# SERVICE INSTRUCTION

DATE: April 28, 2026 Service Instruction No. 1125E  
(Supersedes Service Instruction No. 1125D)  
Engineering design data in this service document is FAA approved.

SUBJECT: Alternate Crankcase Parting Surface Sealants

MODELS AFFECTED: All Lycoming opposed cylinder engines.

**Figure 1**  
**LOCTITE® 515 or 518 and Silk Thread - Recommended**

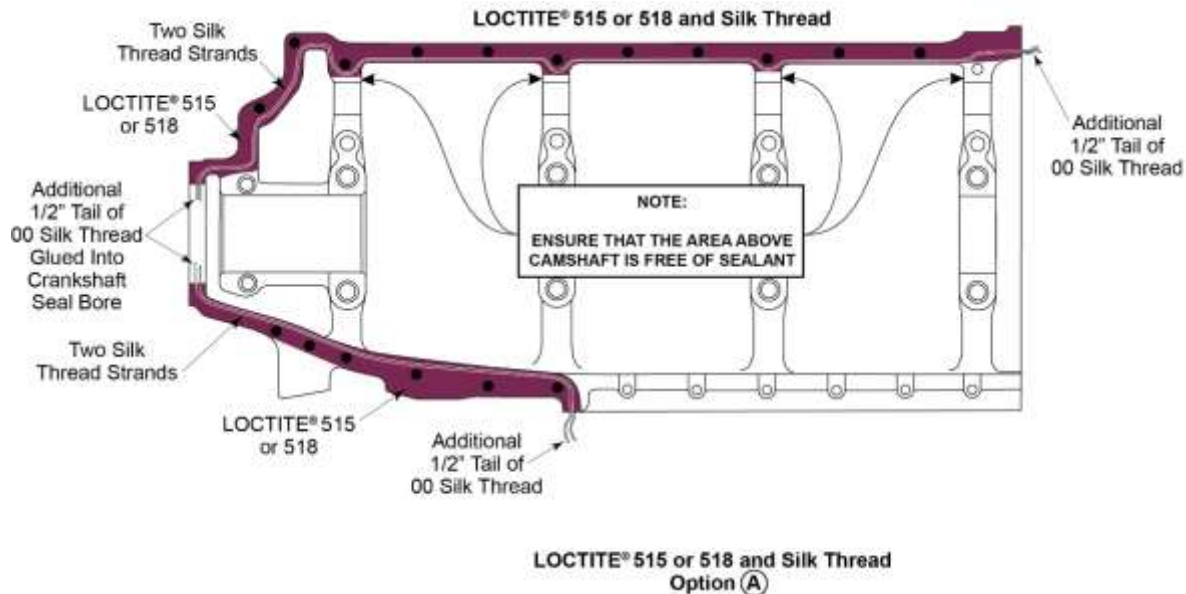
Ensure the crankcase parting faces are cleaned with a de-greasing cleaner, and dry. As shown in Figure 1, apply a film of LOCTITE® 515 or 518 on both halves of the crankcase. The film must be uniform. Visibly, where sealant is properly applied, it will produce a wet appearance on the machined surface. If it does not have a wet appearance, reapply. Be certain to wipe clean all inner edges of any excess sealant. Also, be certain that no sealant has come in contact with the bolt holes or any surface other than the shaded areas shown in Figure 1.

After sealant is properly applied, run two lengths of “00” silk thread on only one of the crankcase halves inside of the bolt holes without touching together and press firmly into sealant to keep thread in place. Any commercial grade of No. “00” silk thread is acceptable.

**Figure 2**

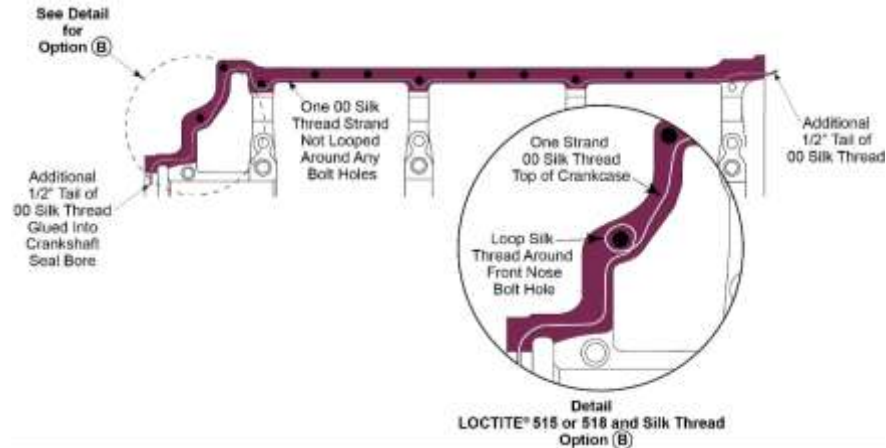
**NOTICE:** The use of LOCTITE® SF 7649 primer with LOCTITE® 515 or 518 is recommended as it promotes better adhesion on aluminum parts. Refer to the LOCTITE® TDS for Directions for use. After sealant is properly applied, run two lengths of “00” silk thread to the bottom of the crankcase (Figure 1) on only one of the crankcase halves inside of the bolt holes without touching together and press firmly into sealant to keep thread in place. Apply a single length of “00” silk thread to the top of the crankcase (Figure 2) on only one of the crankcase halves inside of the bolt holes and press firmly into sealant to keep thread in place or as shown in the Option B Detail, the silk thread can be looped around the front nose bolt hole.

**Figure 3**

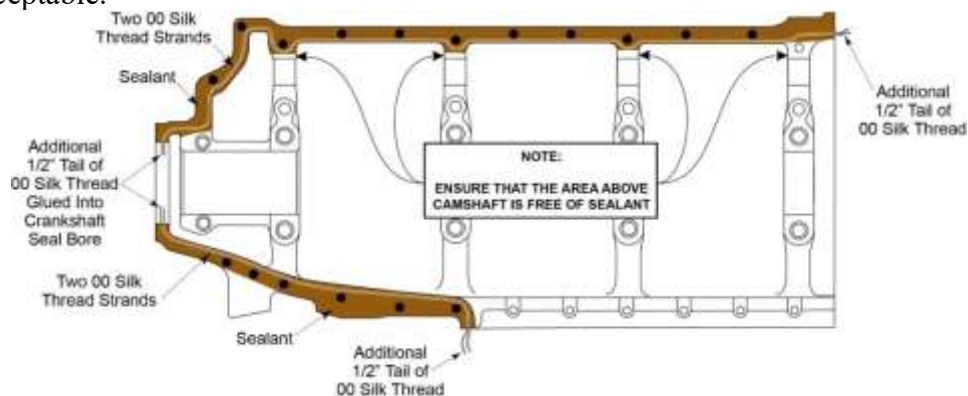
Ensure the crankcase parting faces are cleaned with a de-greasing cleaner, and dry. On the outside mating surfaces, as shown in Figure 3, apply a film of sealant on only one half of the crankcase. The film must be uniform. No build-up is permissible. Visibly, where sealant is properly applied, it will produce a wet appearance on the machined surface. If it does not have a wet appearance, reapply. Note that this sealant is used primarily to hold the “00” silk thread in place. Be certain to wipe clean all inner edges of any excess sealant. Also, be certain that no sealant has come in contact with the bolt holes or any surface other than the shaded areas shown in Figure 3.

After sealant is properly applied, run two lengths of “00” silk thread on the inside of the bolt holes without touching together and press firmly into sealant to keep thread in place. Any commercial grade of No. “00” silk thread is acceptable.

**Figure 4**  
**LOCTITE® 515, 518 or RTV-102 Sealant Without Silk Thread**

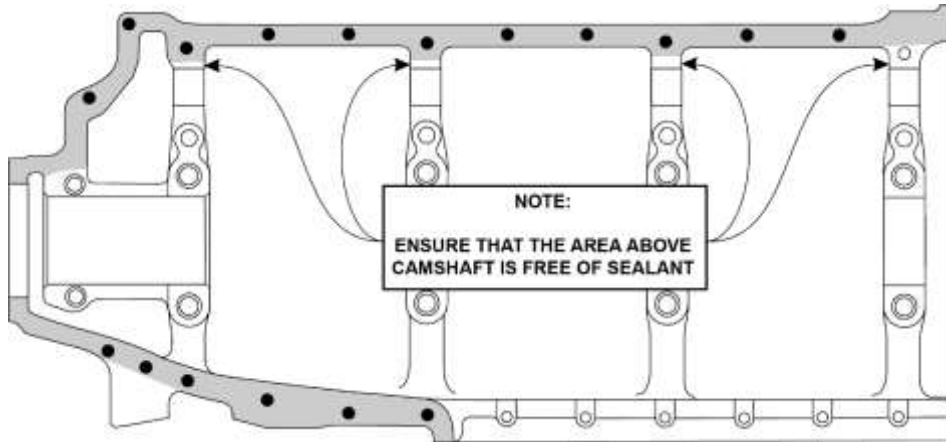
**LOCTITE 515 or 518** - As shown in Figure 4, apply a film of sealant on both halves of the crankcase. The film must be uniform. Visibly, where sealant is properly applied, it will produce a wet appearance on the machined surface. If it does not have a wet appearance, reapply. Be certain to wipe clean all inner edges of any excess sealant. Also, be certain that no sealant has come in contact with the bolt holes or any surface other than the shaded areas shown in Figure 4.

**RTV-102** - As shown in Figure 4, apply a film of sealant on only one half of the crankcase. The film must be uniform. No build-up is permissible. Be certain to wipe clean all inner edges of any excess sealant. Also, be certain that no sealant has come in contact with the bolt holes or any surface other than the shaded areas shown in Figure 4.
